STATE OF CONNECTICUT  
CONNECTICUT SITING COUNCIL

IN RE:	:	
	:	
APPLICATION OF CELLCO PARTNERSHIP	:	DOCKET NO. 495A
D/B/A VERIZON WIRELESS FOR A	:	
CERTIFICATE OF ENVIRONMENTAL	:	
COMPATIBILITY AND PUBLIC NEED FOR	:	
THE CONSTRUCTION, MAINTENANCE	:	
AND OPERATION OF A WIRELESS	:	
TELECOMMUNICATIONS FACILITY AT	:	
5151 PARK AVENUE, FAIRFIELD,	:	
CONNECTICUT	:	DECEMBER 13, 2022

SUPPLEMENTAL RESPONSES OF CELLCO PARTNERSHIP D/B/A VERIZON WIRELESS  
TO CONNECTICUT SITING COUNCIL D&M PLAN INTERROGATORIES

# PLATTSVILLE RELO CT

Figure 1: Graph of General Population % MPE vs. Distance

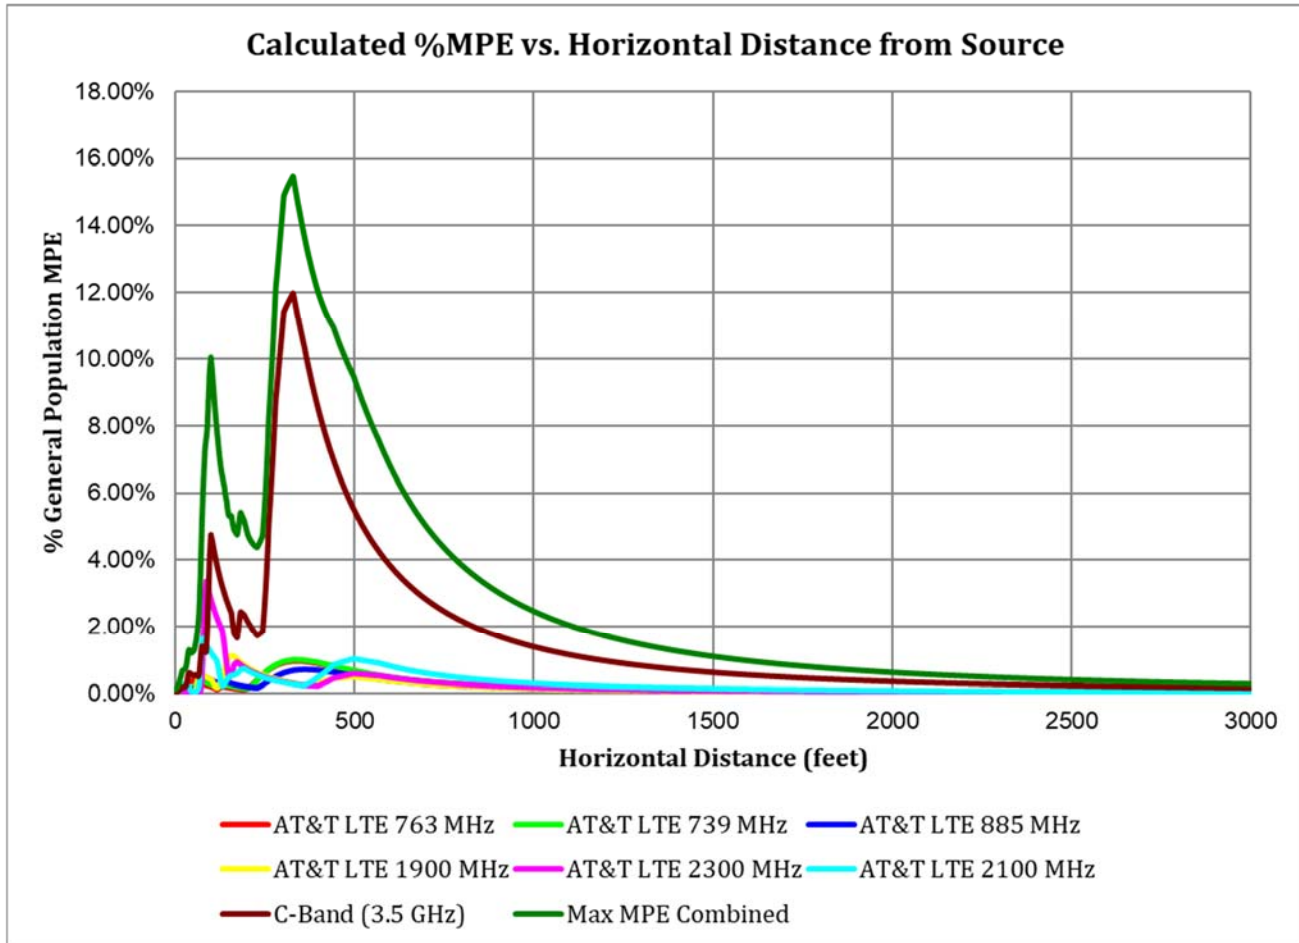
Provide a rigorous cumulative far-field radio frequency analysis for the facility that accounts for Cellco's and AT&T's equipment on the tower, a 6-foot tall person at ground level and the actual antenna patterns for the facility with a cumulative % MPE at or below 100%.

**A copy of AT&T's radio frequency analysis is attached.**

The highest percent of MPE (15.48% of the General Population limit) is calculated to occur at a horizontal distance of 329 feet from antennas. Please note that the percent of MPE calculations close to the site take into account off beam loss, which is determined from the vertical pattern of the antennas used. Therefore, RF power density levels may increase as the distance from the site increases. At distances of approximately 900 feet and beyond, one would now be in the main beam of the antenna pattern and off beam loss is no longer considered. Beyond this point, RF levels become calculated solely on distance from the site and the percent of MPE decreases significantly as distance from the site increases.
